CODE: CC-291

DATE: DECEMBER 2, 1994

SUBJECT: SERIES 2000 TRANSMISSION AXLE RETAINING RING, (MODELS 2130 - 2185) REGARDING TRACTORS WITH BUILD DATE CODES BETWEEN: K164G - K214G.

RETAINING RING (716-3018)

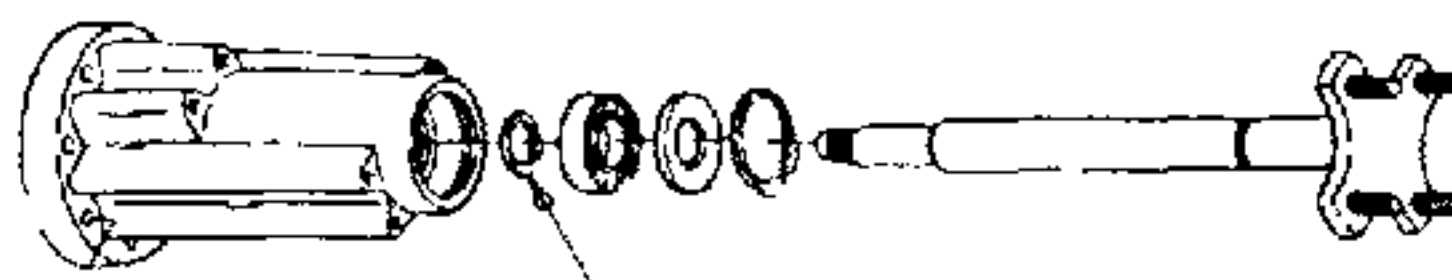
PROBLEM: WE HAVE FOUND IN SOME INSTANCES THAT THE RIGHT AXLE RETAINING RING HAS BEEN INSTALLED IMPROPERLY.

INSPECT THE INNER RETAINING RING TO VERIFY IF THE RING IS PROPERLY SEATED INTO THE GROOVE ON AXLE. NOTE: THERE WILL BE A RING END GAP OF APPROXIMATELY 1/8 OF AN INCH WHEN SEATED IN THE GROOVE.

CLEAN THE SEALING SURFACES OF THE TRANSMISSION AND AXLE HOUSING AND APPLY ULTRA GRAY SEALANT (759-3746) TO ONE OF THE SURFACES. REASSEMBLE THE AXLE HOUSING TO THE TRANSMISSION, TORQUE THE BOLTS TO 180- 200 in. lbs.
